**SECTION 96(2) MODIFICATION APPLICATION
2 MORTON STREET, PARRAMATTA (D/2012/391/A)**

This Statement of Environmental Effects (SEE) is submitted to Parramatta City Council in support of a section 96(2) application to modify Development Consent D/2012/391/A relating to 2 Morton Street, Parramatta.

Figure 1 – Modified landscape concept

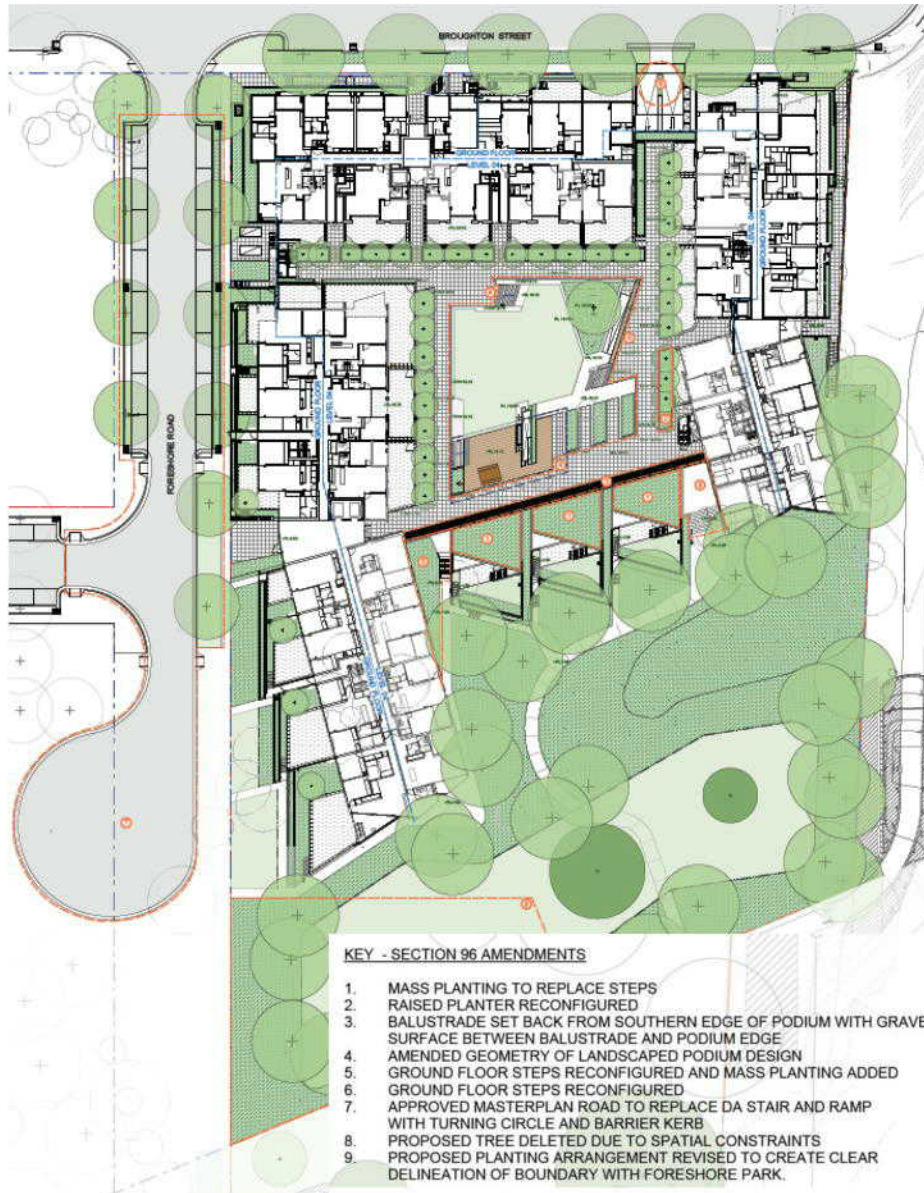
Several modifications have been made to the landscape design in response to the changes to the podium access, as well as through general design development changes. Aspect Studios have prepared revised Landscape Plans and a Landscape Statement (refer to **Attachment C**). The changes are shown at **Figure 1** and include:

- Replacement of the steps on the rooftops of the terraces at Building A4 with mass planting. Planters on these rooftops will contain low maintenance ground covers and native grasses with low water requirements.
- Amendments to the shape and dimensions of a raised planter on the eastern edge of the landscaped podium to accommodate a revised fire stair.

- Setting back the balustrade from the southern edge of the podium, and providing a gravel strip between the balustrade and the podium edge.
- Modifications to the general layout of the central podium to provide a greater variety of spaces with multiple seating opportunities. The revised design aligns the landscape and building geometries to provide a more cohesive scheme.

- Reconfiguration of the western access steps from the foreshore open space to the ground floor, and inclusion of mass planting to soften this entry.
- Reconfiguration of the eastern access steps from the parkland to the ground floor.

Figure 2 – Approved stair between Building A1 and Building A4 (circled in red)

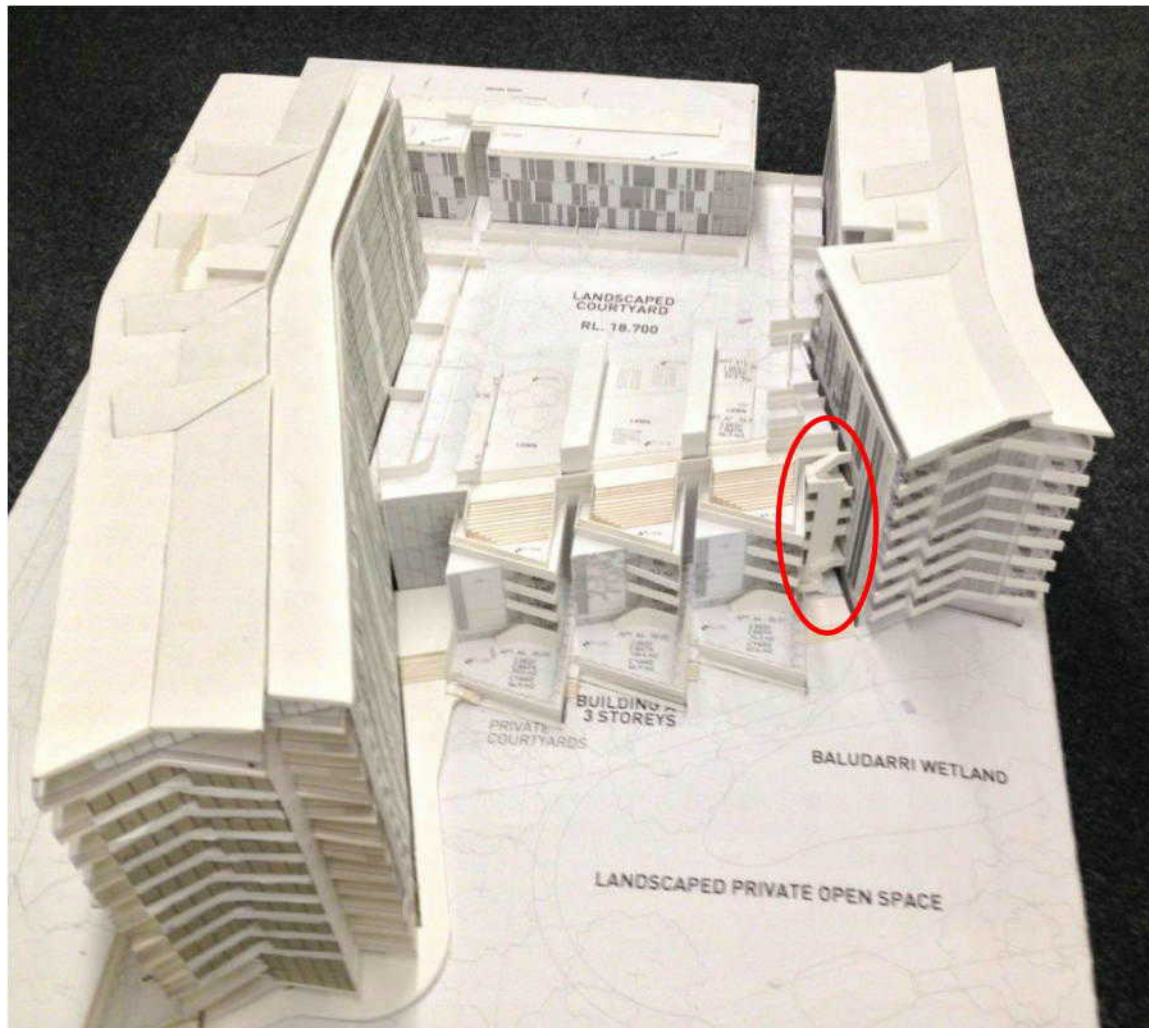
As shown in **Figure 2**, the original stair which was proposed to link the podium to the foreshore was not well resolved, and resulted in a sub-optimal design outcome. The revised design seeks to remove the external stair and instead provides access via new external steps at ground level, which lead to an internal lobby area where a glass fronted staircase provides access up the podium level. The modification also seeks to remove the steps on top of the terraces at Building A4 and replace them with landscaped planters.
